Application by Highways England for an Order granting Development Consent for the M25 Junction 28 Improvements scheme

Written Representation submitted on behalf of Luddington Golf Ltd.

Planning Inspectorate Reference No: TR010029

Response to Highways England letter of 10th December 2020 proposing how Maylands Golf Course should be altered

Highways England Option

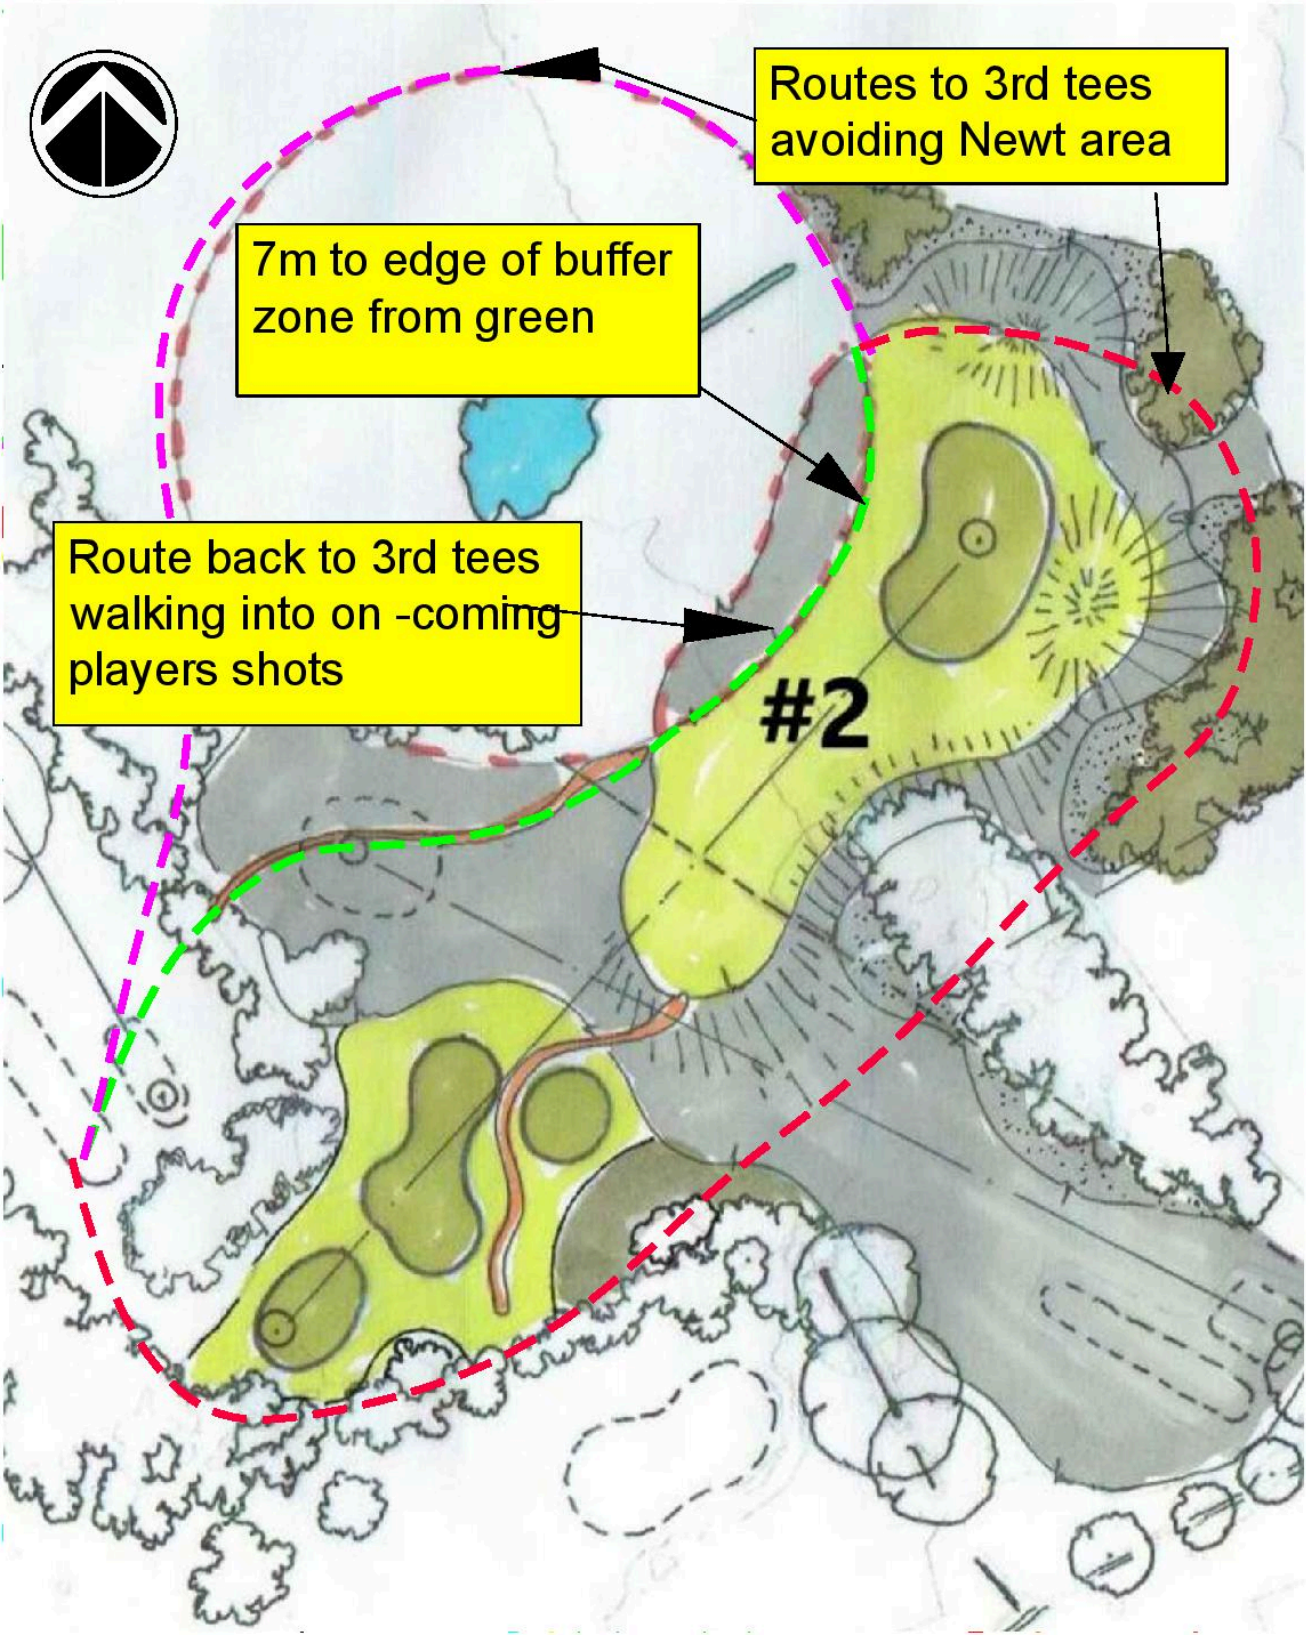
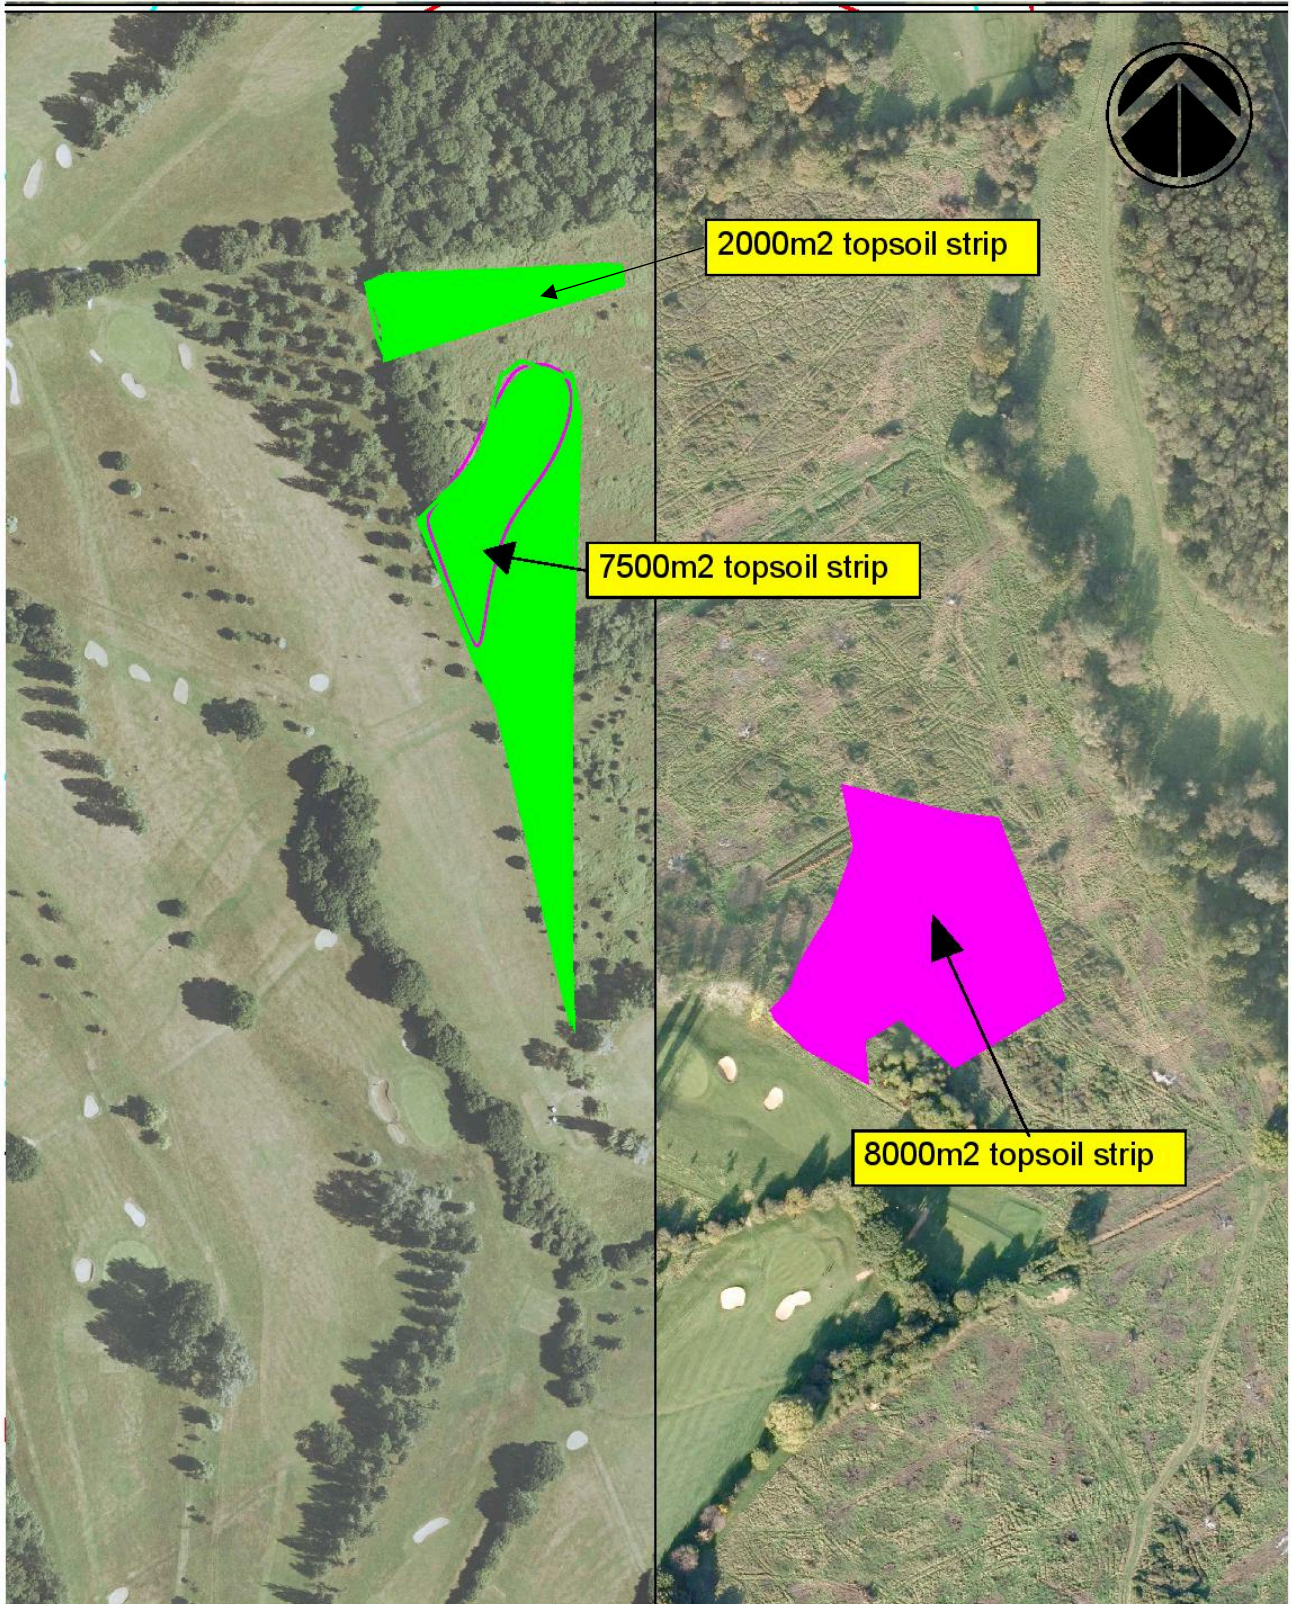
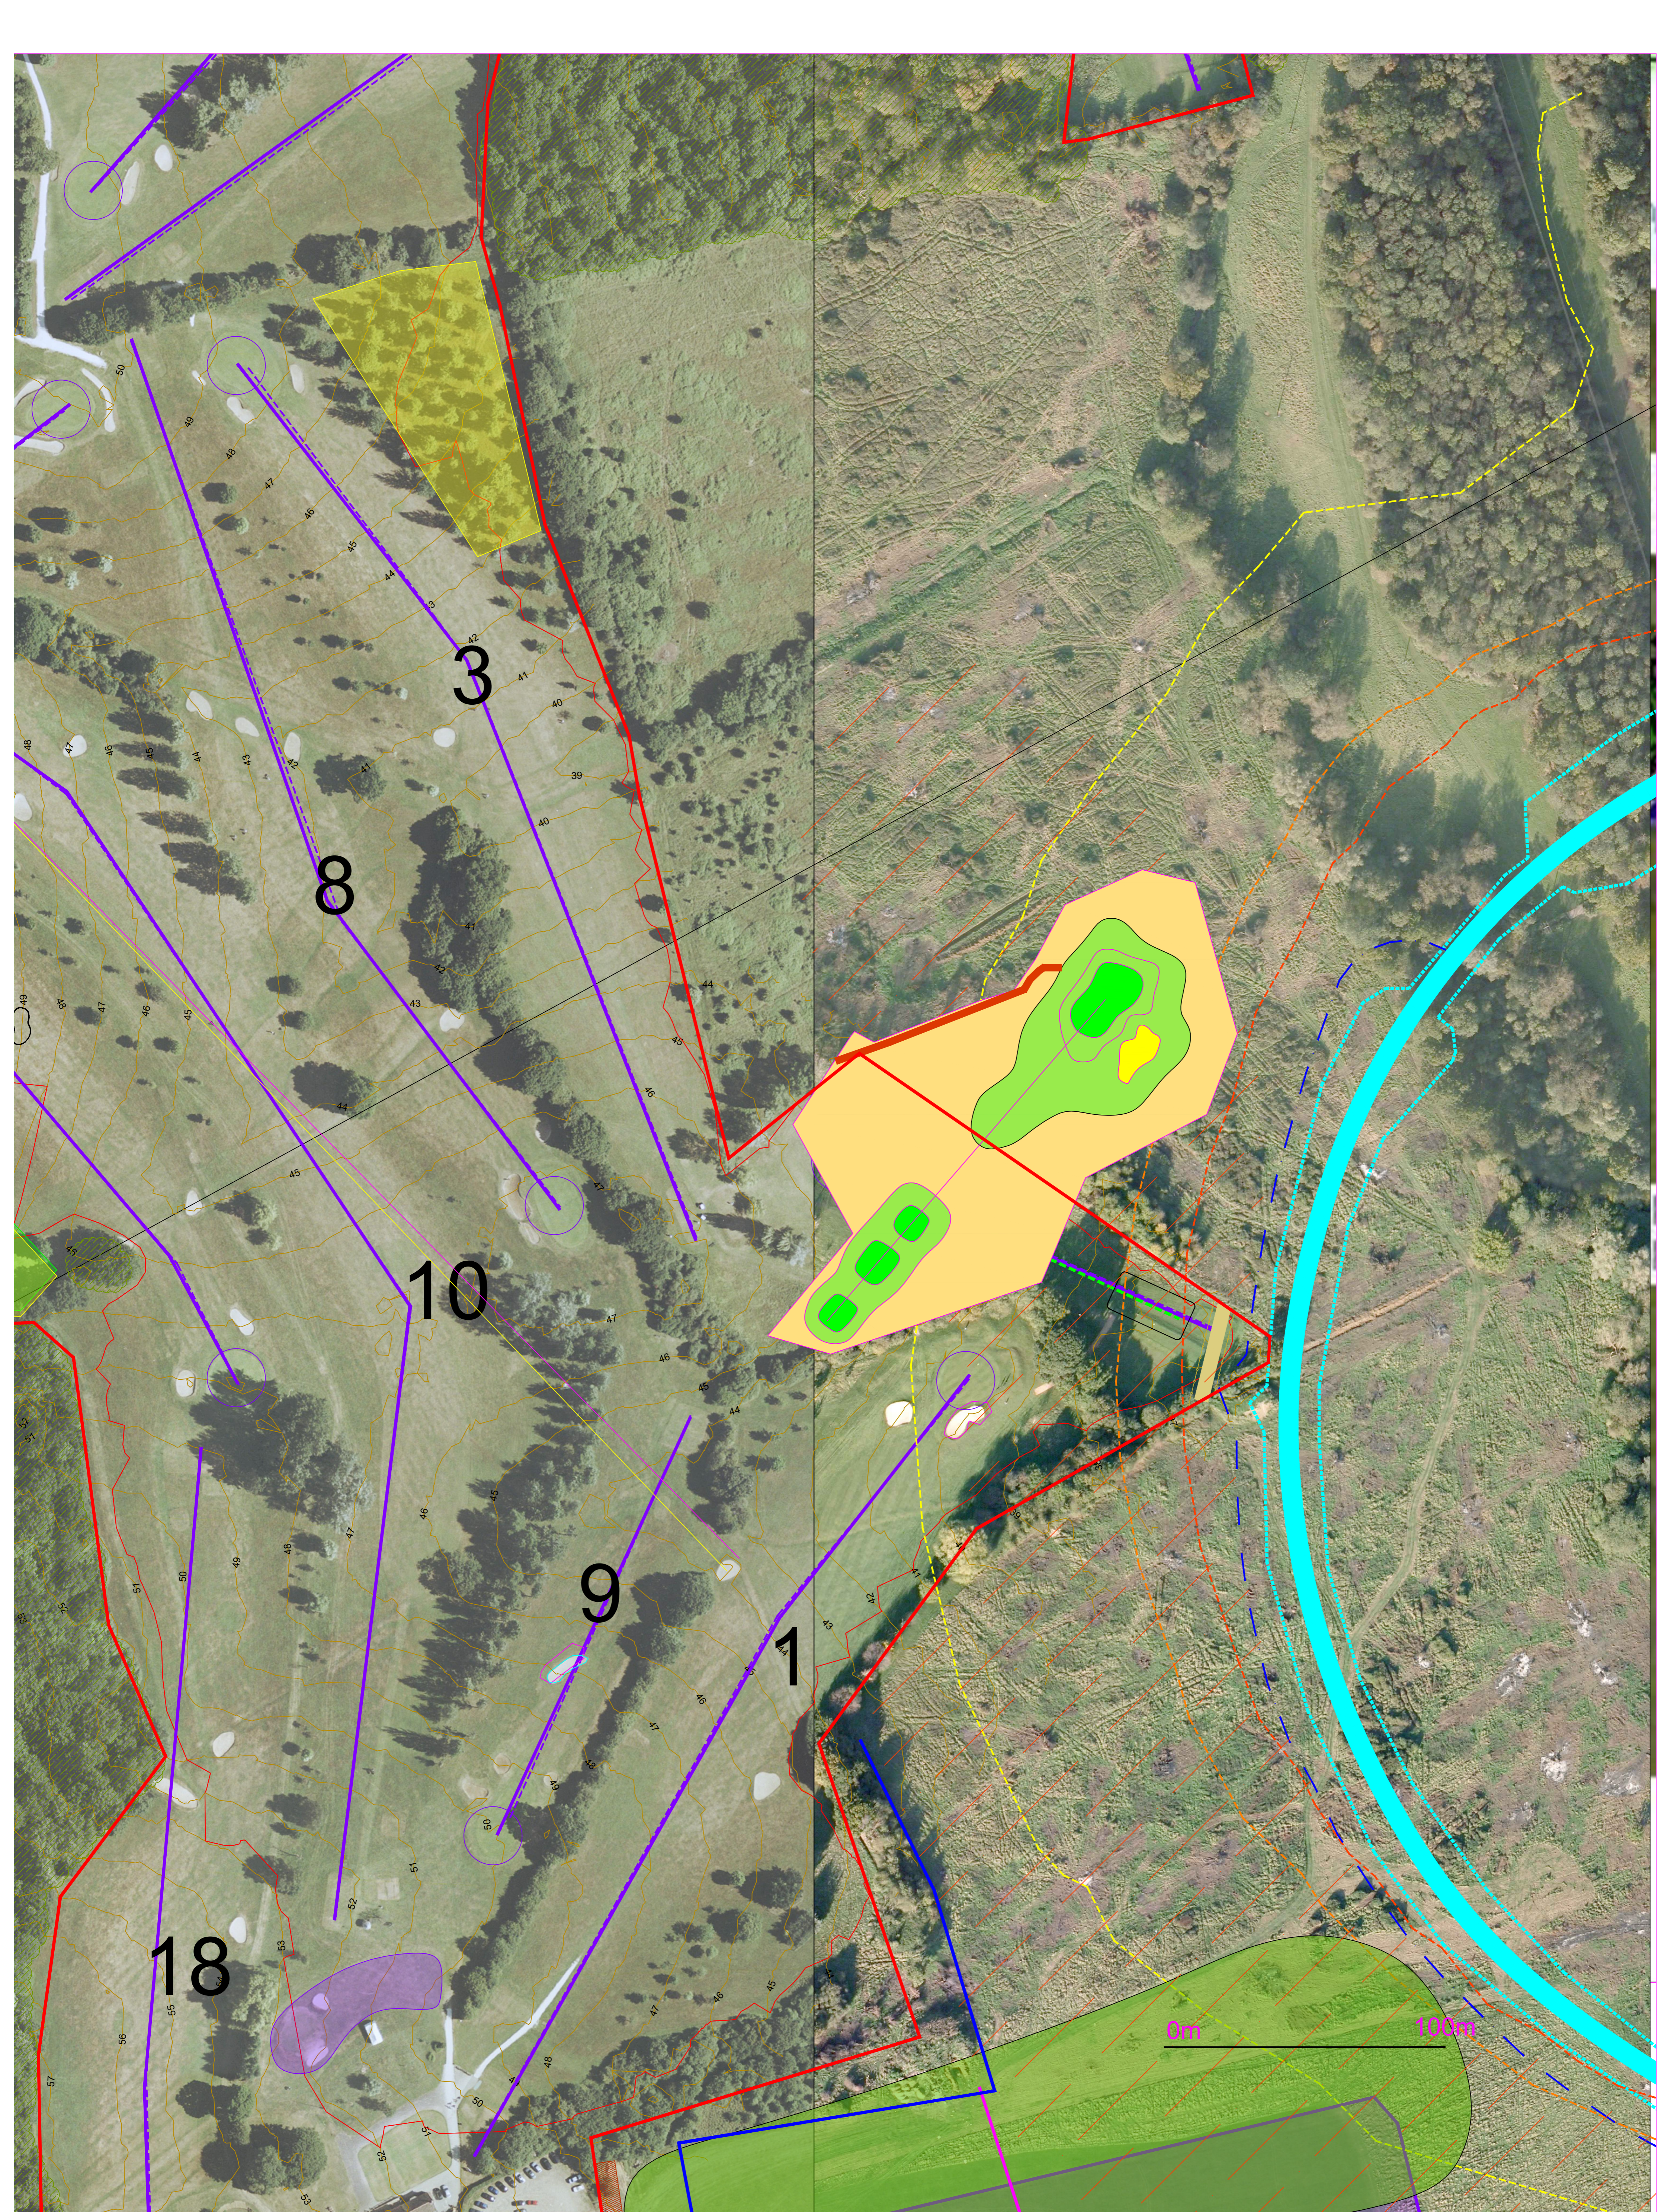
10.2.2 Based on the drawing provided there appears to be a route indicated (red dashed line) back to a new pathway to the 3rd tees (170m in length). We have concerns over safety of golfers based on this route. Golfers would be walking straight back into the hitting zone of the proceeding golfers playing the 2nd hole which would not be acceptable. While it could be possible to make players on the 2nd tee wait until those leaving the 3rd hole were clear of danger, this would result in a considerable delay and queuing of players on the 1st and 2nd holes.

Route back to 3rd tees walking into on-coming players shots

Pink = Extent of strip for Highways England Option
Green = Extent of Strip for Weller Designs Option 1 (amended to reduce extent to east of fairway)

Figure 7: Proposed change for Work No. 32

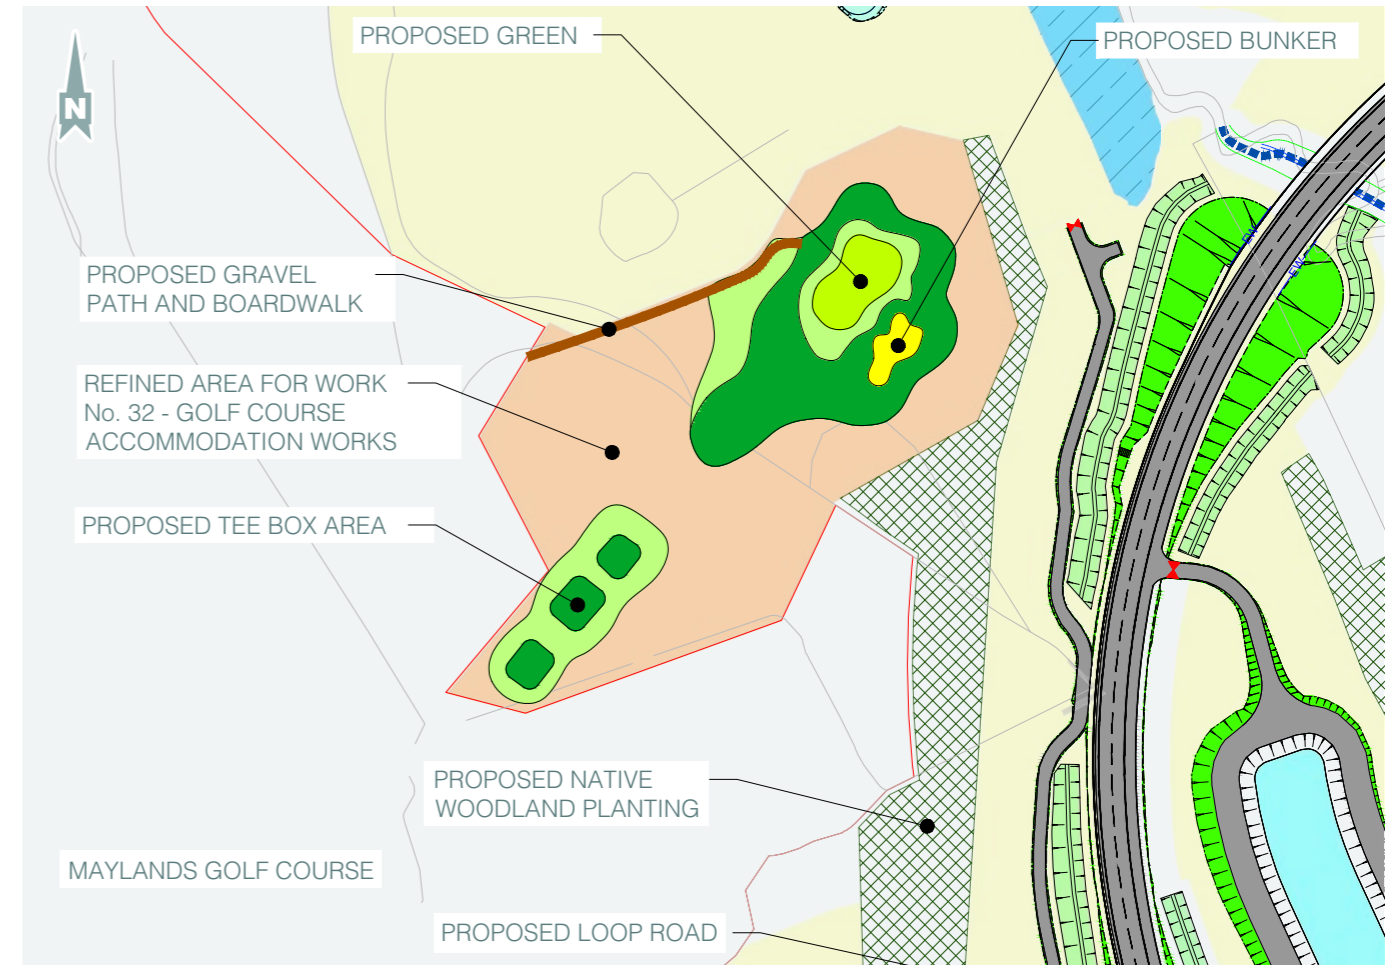
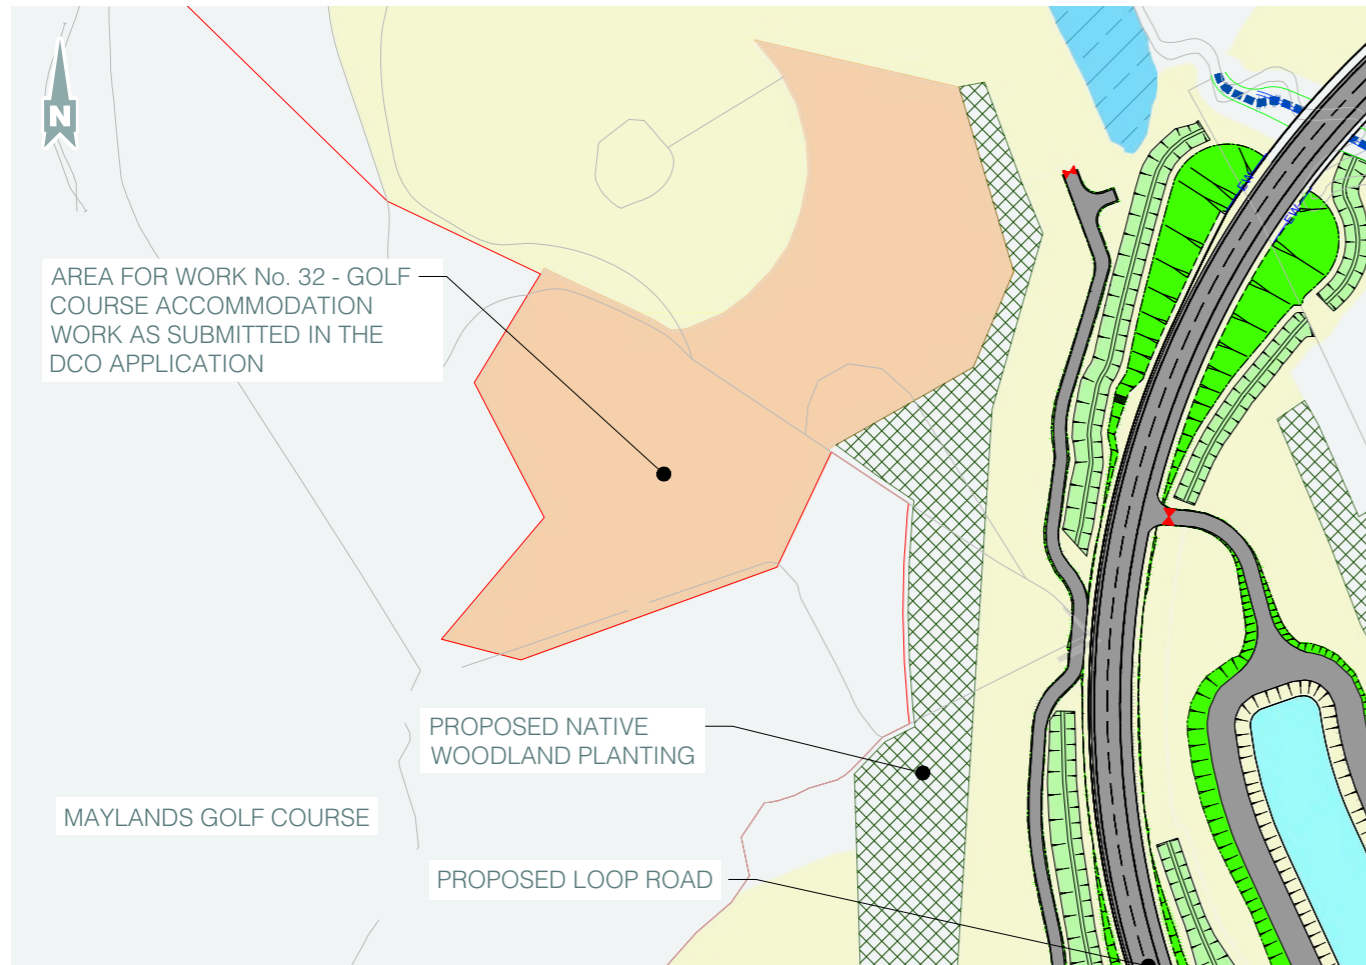
- 2.2.1 Note See Applicants Solution in Appendix A and B . Weller Solution see Appendix C and D)
- 2.2.2 The introduction of the boardwalk and path does not solve the safety issue and will slow play up whilst golfers have to wait for the path to clear.

- 2.2.3 The path / boardwalk lies within the “safety cone” for stray shots to the left. Safety guidance can prove this to be more unsafe than the current set up which cannot therefore be regarded as a like for like replacement.

- 2.2.4 Maylands GC has a serious issue with basically playing the hole and then literally walking back the same hole to play from the third tees (the desire line is straight back down again and golfers will take shortest route back to the back of the third tees).

- 2.2.7 The path / boardwalk of some 80m necessitates an on-going and substantial maintenance issue / cost.
- 2.2.8 The introduction of the 'environmental bund' if, as quoted in the Highways England (HE) brochure, is going to be circa 2.5m, such a height will not provide a visual screen to lorries and it is questionable, as regards noise impact, it will have a great effect (no evidence of revised acoustic study has been provided by HE) especially as it is well known by acoustics engineers that there is a correlation between traffic noise and seeing the actual traffic movements which makes the perceived noise greater.

- 2.2.18 It is not acceptable to place a significant structure (essentially a bridge where two vehicles can pass) over a newt pond when easier options are available.
